5 November 2025

Response to Information Request for Preliminary Approval for Material Change of Use (Variation Request) at 203 Ashmore Road, Benowa (Council ref: MCU/2025/79)

Figure 1 Staging Plan

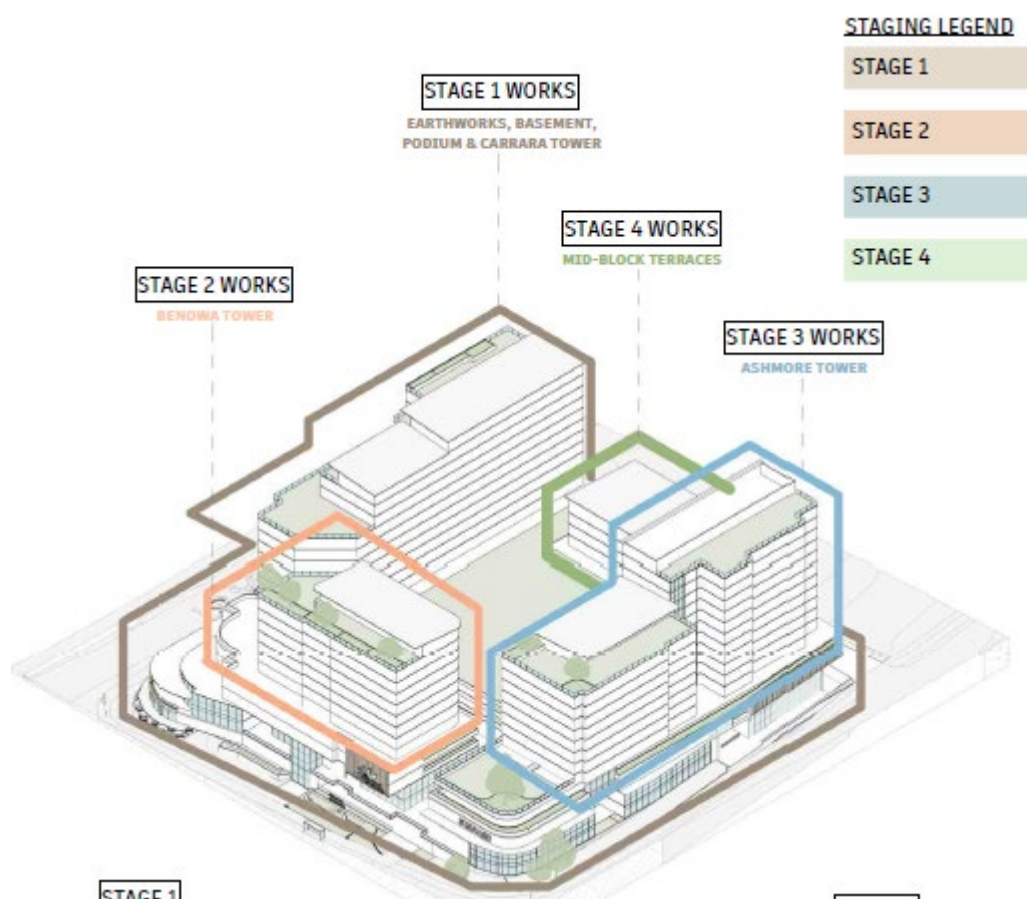
The concept plans provide a staging plan. The applicant is requested to clarify the intended staging of the development for the purpose of delivering infrastructure and any required works.

This reflects the below Staging Plan, included in **Appendix C**, which has also been incorporated as a Performance Outcome in the Plan of Development in **Appendix B**.

Given the entirety of the basement and podium levels will be delivered as part of Stage 1, the balance of the development will have necessary services, infrastructure and car parking available at the time of construction.
